UNITED STATES PATENT AND TRADEMARK OFFICE

10/810,203

Office Action Summary	Application No. 10/810,203	Applicant(s) KANG ET AL.	
	Examiner David S. Kim	Art Unit 2613

DETAILED ACTION

FIG. 5

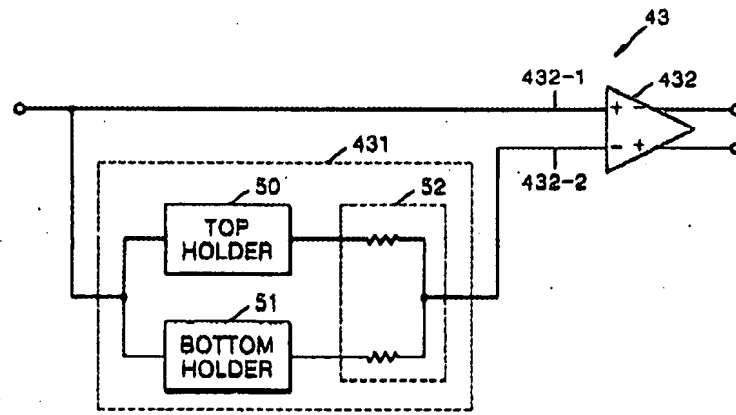
the "series of sets" (in the preamble) includes multiple auto-offset cancellation portions, which is in contrast with each set having one auto-offset cancellation portion (see corresponding Fig. 5).

Disapproved by DSK
21 August 2007

FIG. 6

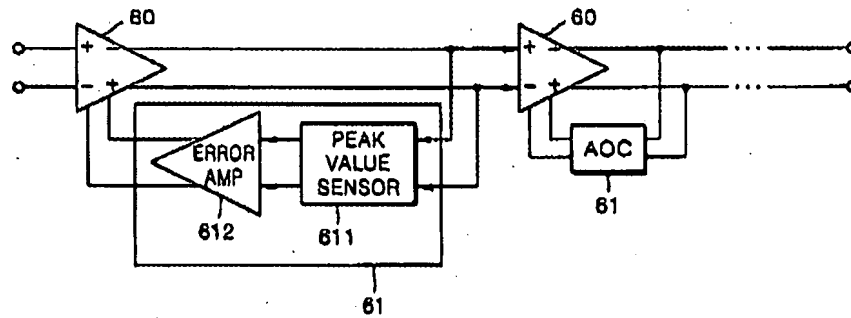
- 1) The connections from the peak value sensor to the error amp in Figs. 6-7 are not supported. As a simple remedy, Examiner suggests the simple removal of these connections.
- 2) The connections from the error amp to the output lines in Figs. 6-7 are not supported. As a simple remedy, Examiner suggests the simple removal of these connections.

Disapproved by DSK
21 August 2007

2. Corrected drawing sheets in compliance with 37 CFR 1.121(d) are required in reply to the Office action to avoid abandonment of the application. Any amended replacement drawing sheet should include all of the figures appearing on the immediate prior version of the sheet, even if only one figure is being amended. The figure or figure number of an amended drawing should not be labeled as "amended." If a drawing figure is to be canceled, the appropriate figure must be removed from the replacement sheet, and where necessary, the remaining figures must be renumbered and appropriate changes made to the brief description of the several views of the drawings for consistency. Additional replacement sheets may be necessary to show the renumbering of the remaining figures. Each drawing sheet submitted after the filing date of an application must be labeled in the top margin as either "Replacement Sheet" or "New Sheet" pursuant to 37 CFR 1.121(d). If the changes are not accepted by the examiner, the applicant will be notified and informed of any required corrective action in the next Office action. The objection to the drawings will not be held in abeyance.
